Text of Oral Submission to NSIP 14/5/25 Professor David Sherratt (note the text in red was not in my oral presentation)

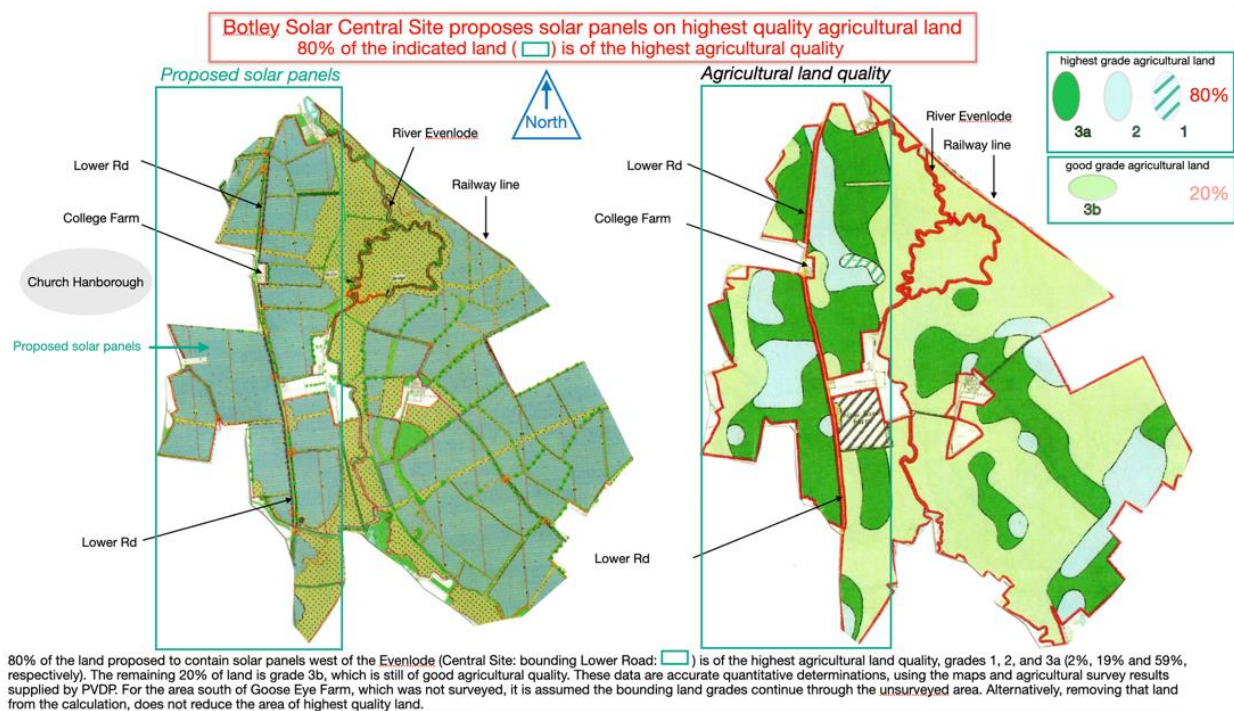
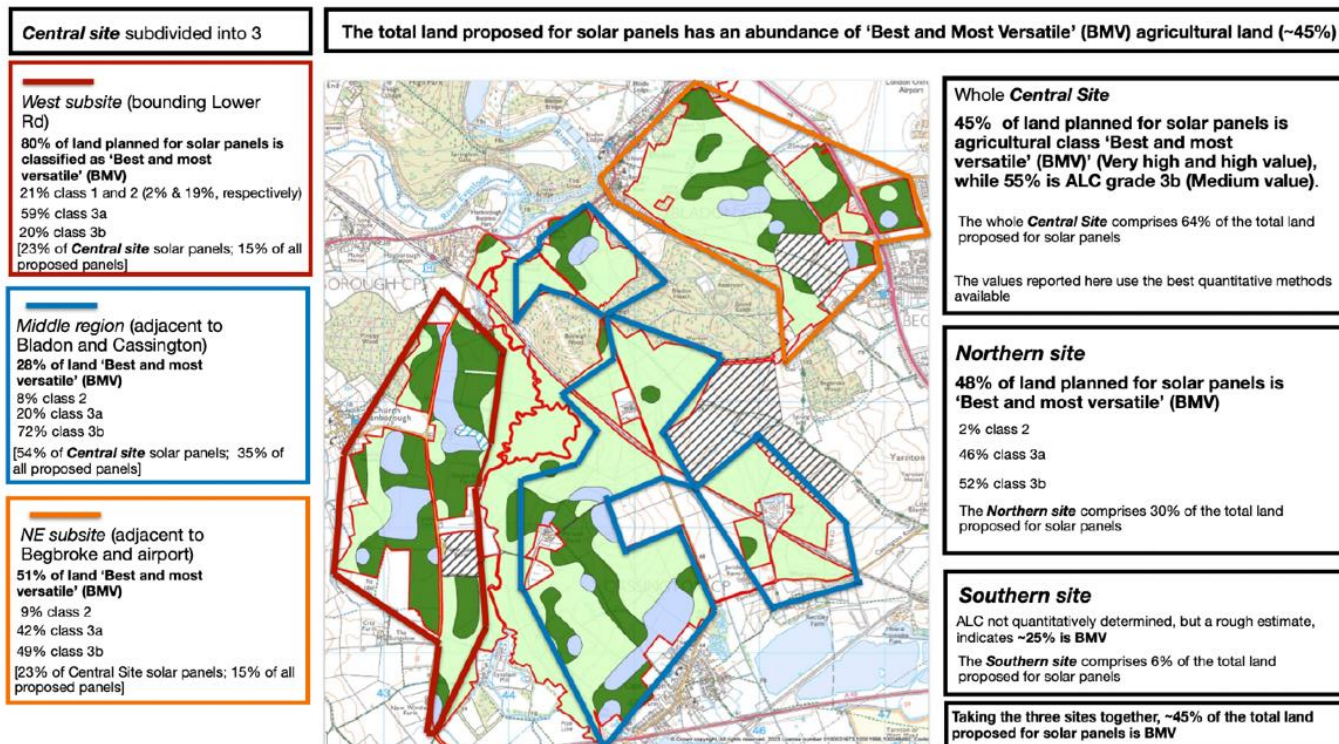
My own careful calculations for different areas of the whole site indicate that for the subsequently reduced area of land proposed for solar panels, this figure for BMV is closer to 45%. Furthermore, in the central region area, the land west of the Evenlode river, adjacent to Hanborough, comprises ~80% BMV by my quantitative calculations **(see Appendix below for details of the calculations)**. Government guidelines and WODC policy state 'any proposal for a solar farm involving the best and most versatile agricultural land would need to be justified by the most compelling evidence'. This compelling evidence remains lacking. **The 80% BMV land west of the Evenlode (~15% of all panels) should be removed from any solar farm development.**

My analyses yield a higher value of Best and Most Versatile (BMV) (~45%) for the whole site than the figure (~38%) provided by the applicant. This may be because the PVDP analysis used their original solar panel plan rather than the revised plan, which now excludes panels from a significant amount of ALC 3b land. It would be helpful if the applicant provided details of the methods for their calculations, thereby allowing an independent assessment of their accuracy. I also note that in their Fig. 17.2 (Predictive Best and Most Versatile Land Assessment) is erroneous and misleading-most of the planned development should be on land that is coloured mauve (20-60% BMV). The data in table 17.15 (Table 17.9 in the original documents) that 59% of the land proposed for solar panels is less than 20% BMV neither accords with their own data nor with my calculations. Similarly, 'the high likelihood of BMV land equals 1%' is inconsistent with the information shown for the west sub-site of the Central region, where ~80% of the land is BMV and constitutes ~15% of the total development; i.e. ~10% should replace 1% in Table 17.15 (originally Table 17.9).
